CURTISS P-40
BULLETINS

TECHNICAL ORDER
No. 01-25C-7

CURTISS—OPERATION, MAINTENANCE, AND INSTALLATION INSTRUCTIONS FOR CARBURETOR AIR FILTERS—P-40E, P-40E-1, P-40K SERIES AND P-40M

Figure 3 - Attachment Reinforcement Showing Rivet Spacing

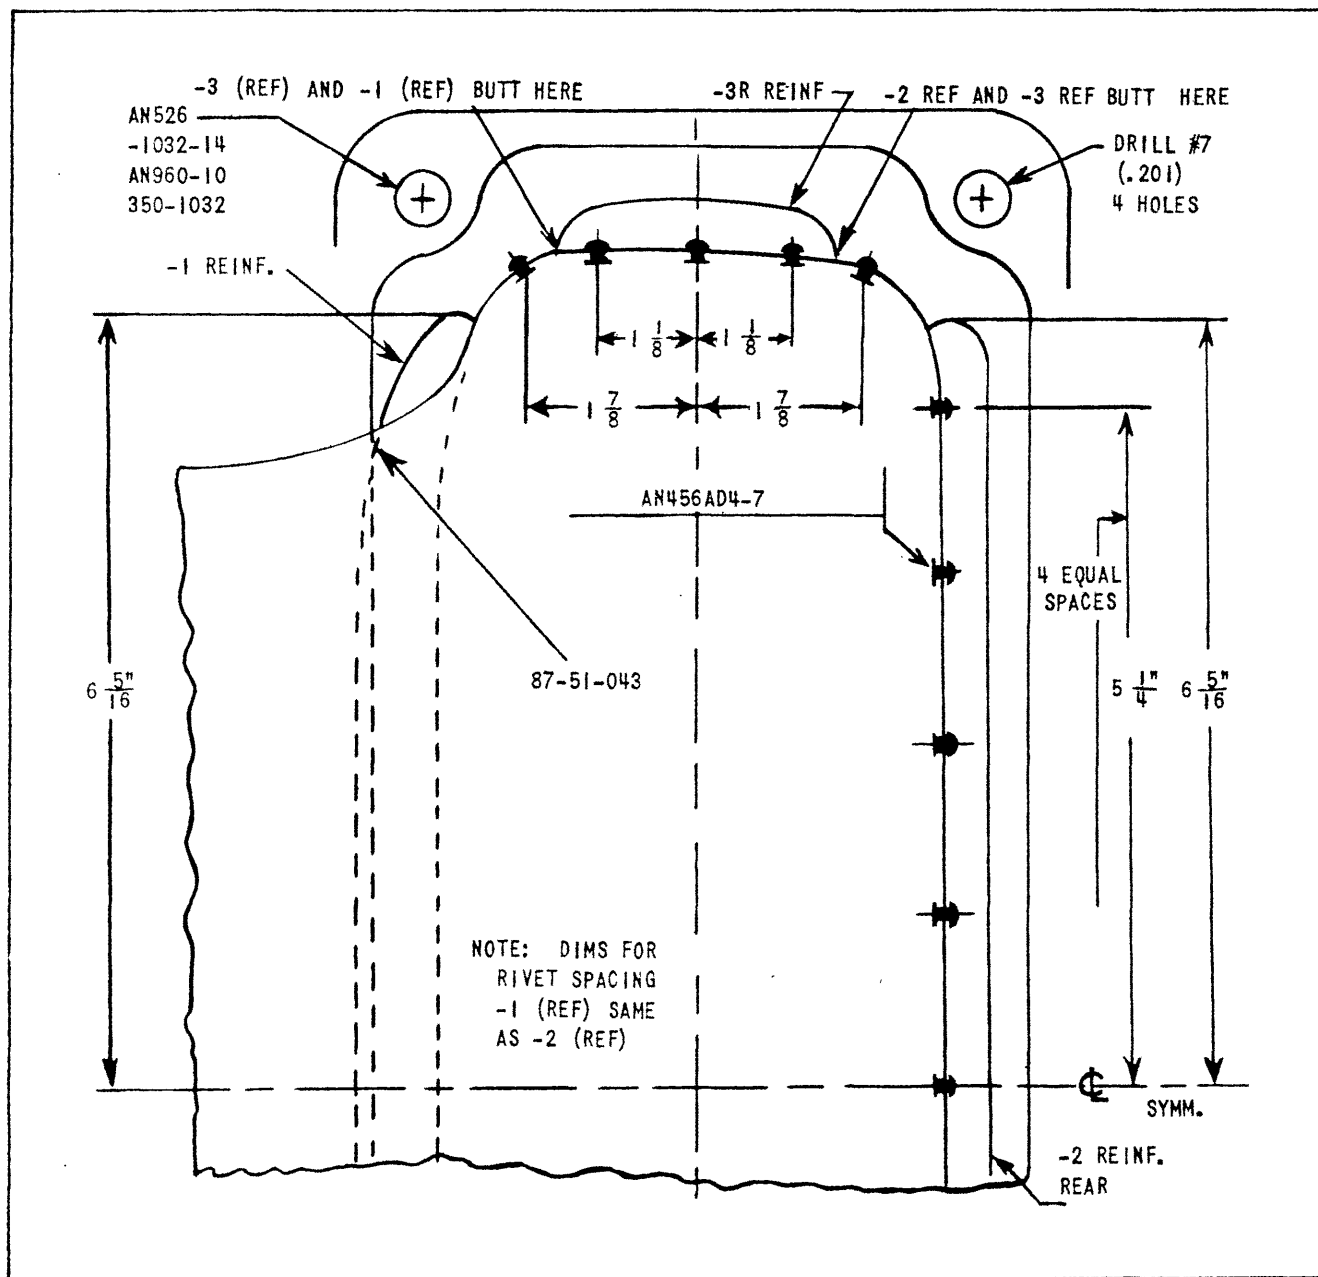
d. Clamp the neoprene sleeve, part No. 87-51-062 (or some acceptable substitute) and reinforcements, part Nos. 87-51-713-1, -2, -3R, -3L, in place on elbow, part No. 87-51-043, as shown in figure 2.

g. Clamp lower plate assembly, part No. 87-51-063, to carburetor valve body, part No. 87-51-018, as shown in figure 2.

No. 87-51-018, with No. 30 (.128) drill, as shown in figure 2.

j. Slide the upper plate assembly, part No. 87-51-064, on the neoprene sleeve, part No. 87-51-062, as shown in figure 2.

Figure 1- Elevator and Bearing Ass'y Top View

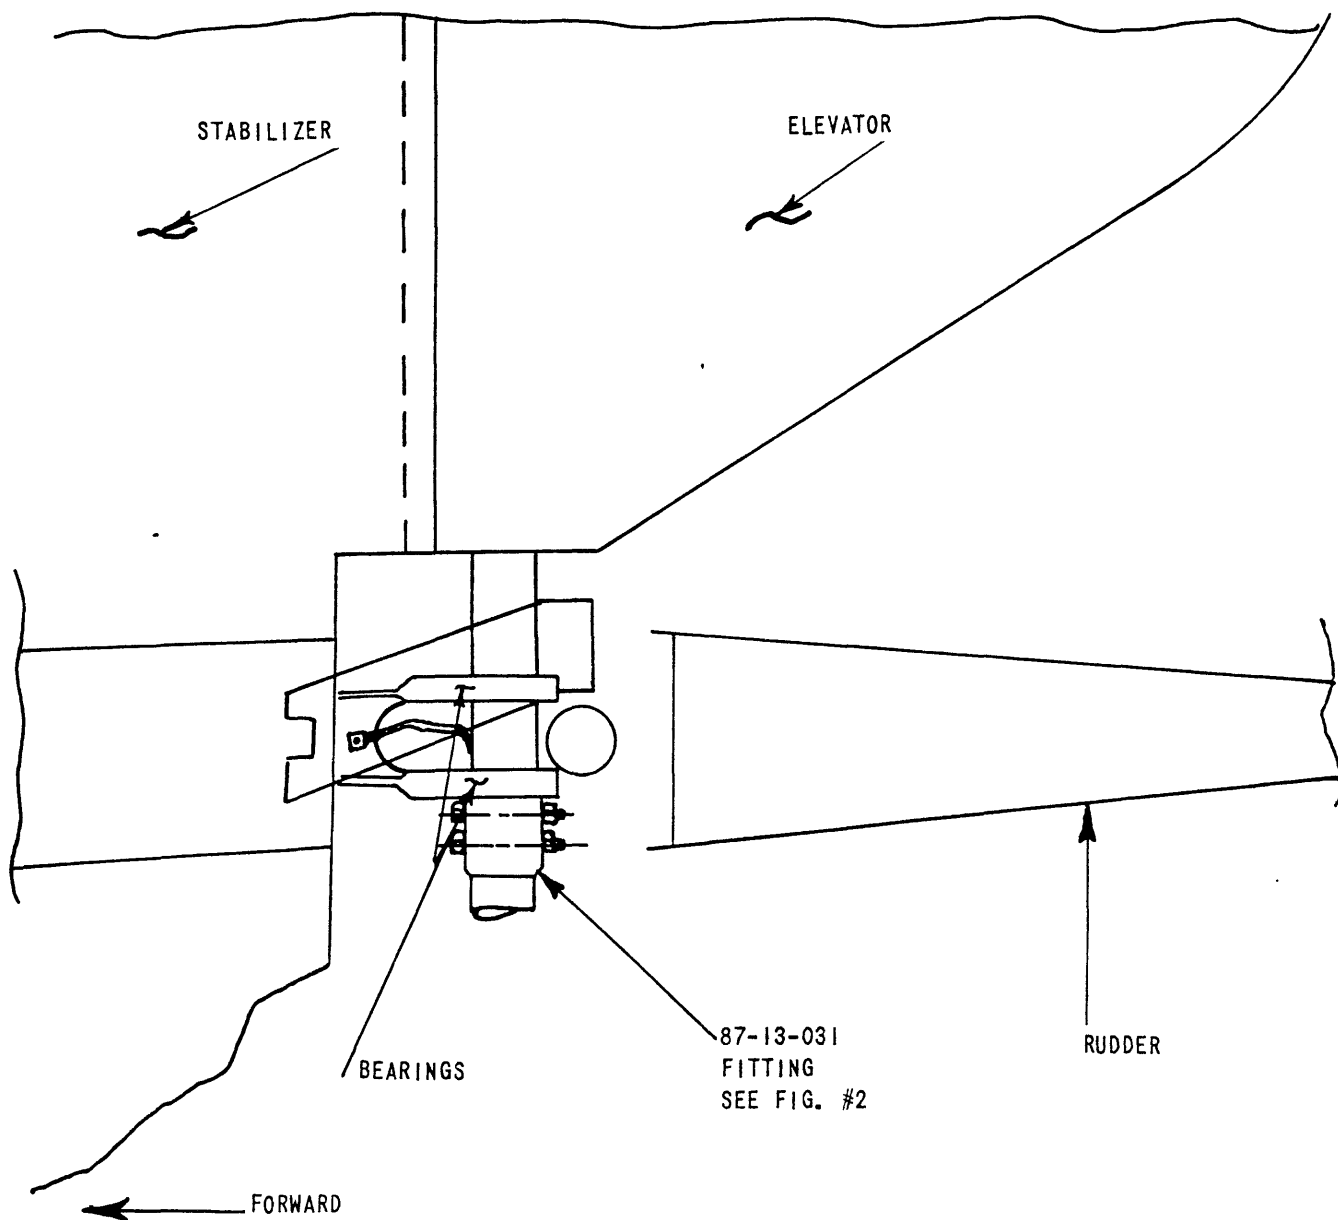
a. Remove all oil and grime from the outer surfaces of the two elevator fitting bearings and the center and lower rudder hinge bearings. (See figures 1 and 4.)

Figure 2 - Pulley Bracket,
Part No. 87-64-928 and
Plate, Part No. 87-37-552

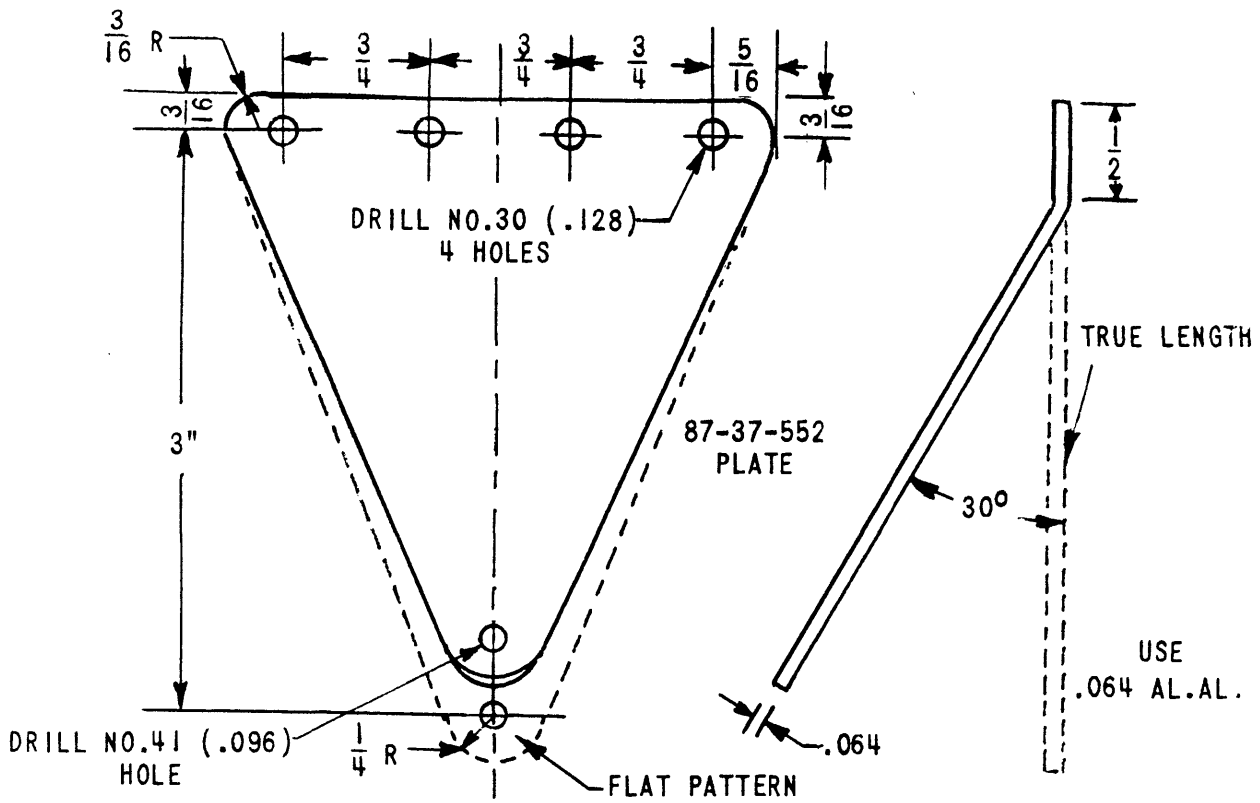
(5) Remove one pulley, part No. 86554, from the pulley assembly, assemble the new pulley brackets, part No. 87-64-928, fabricated in accordance with figure 2, detail (B), using the removed pulley, part No. 86554, and the new pulley, part No. AN210-3A, as shown in figure 1, and secure to station 13 with four screws, part No. 515-8-8, four washers, part No. 960-8, and four nuts, part No. 365-832, using the original holes in station 13.

(6) Remove the two rivets, holding the plate on top of the flange of the cross tube and install new plate, part No. 87-37-552, fabricated in accordance with figure 2, detail (A), as shown in figure 1, with four screws, part No. 515-6-7, four washers, part No. 960-6, and nuts, part No. 365-632, utilizing the two existing holes and drilling the two other holes with a No. 30 (.1285) drill.

Figure 4 - Reinforcement of Fuselage Bulkhead, Station 12 (RP-40, RP-40B, RP-40C, and RP-40G.)

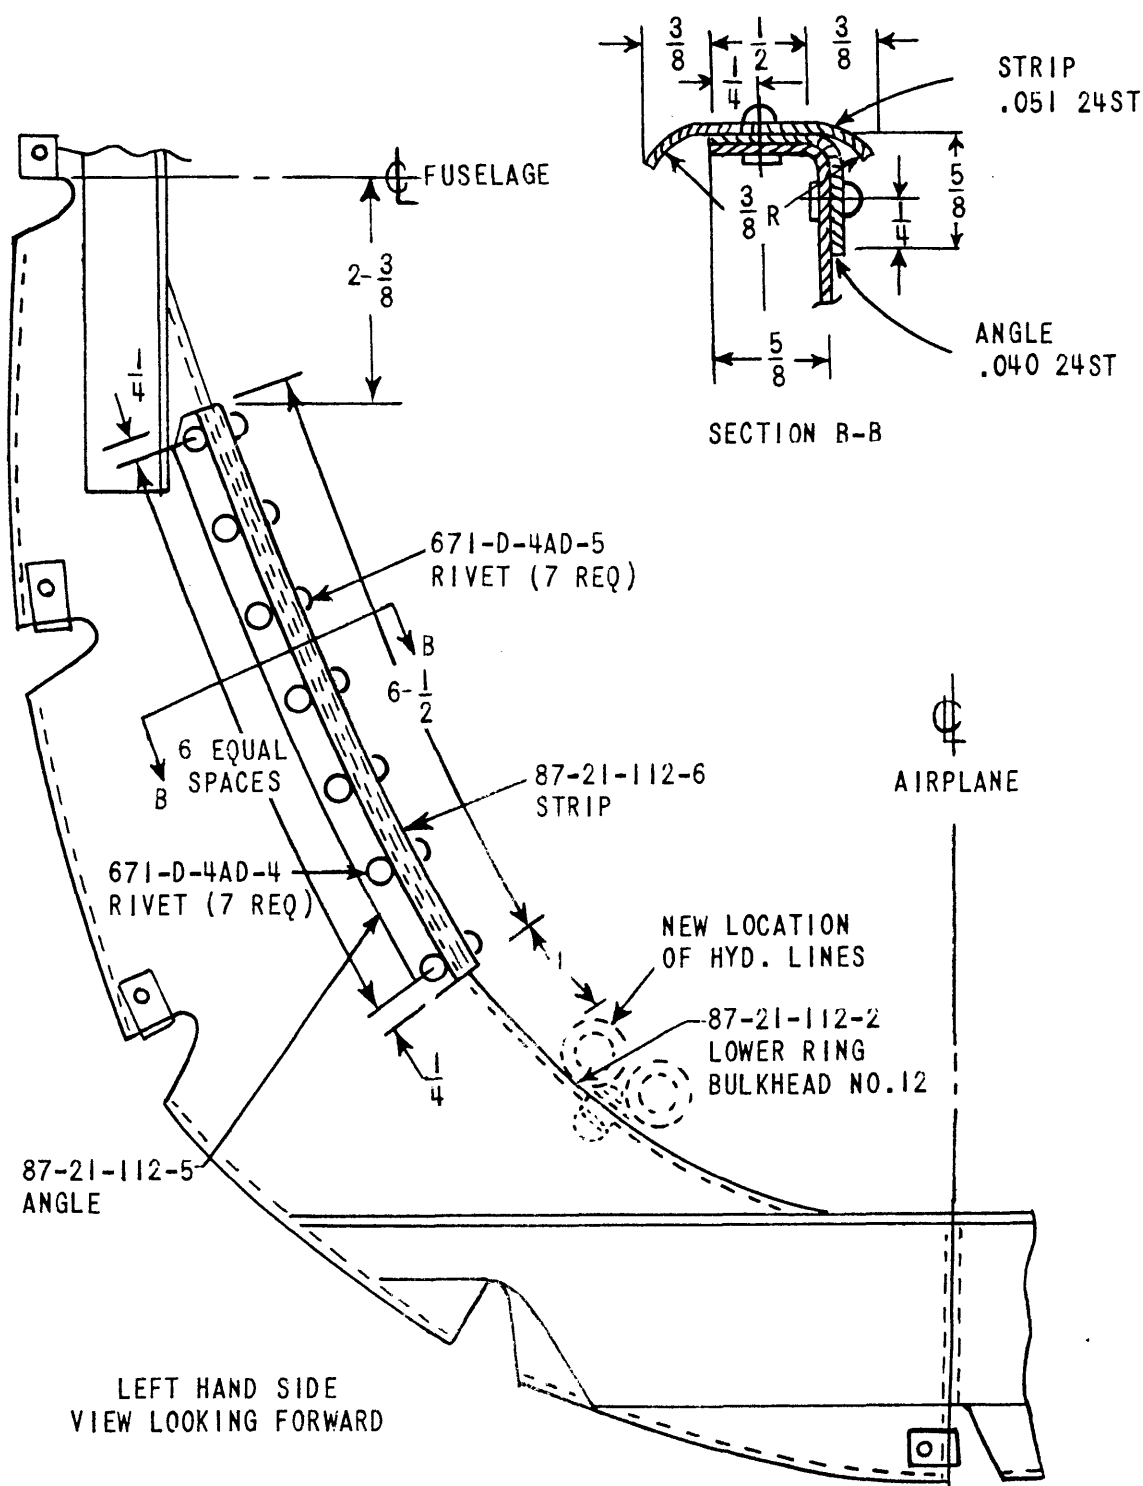
(3) Using aluminum alloy sheet, Specification No. QQ-A-355, make angle, as shown in cross section (B-B) of figure 4 and approximately 6-1/2 inches long. The production part number for this angle is 87-21-112-5L.

(4) Hold angle against bulkhead flange of lower left-hand ring with upper end 2-3/8 inches from top of center line stringer. Drill seven No. 30 (.128) holes through angle and bulkhead as shown in figure 4.

(6) Cut another strip, either stainless steel or Alclad, approximately 1-1/2 x 6-1/2 inches and bend down edges as in section B-B of figure 4.
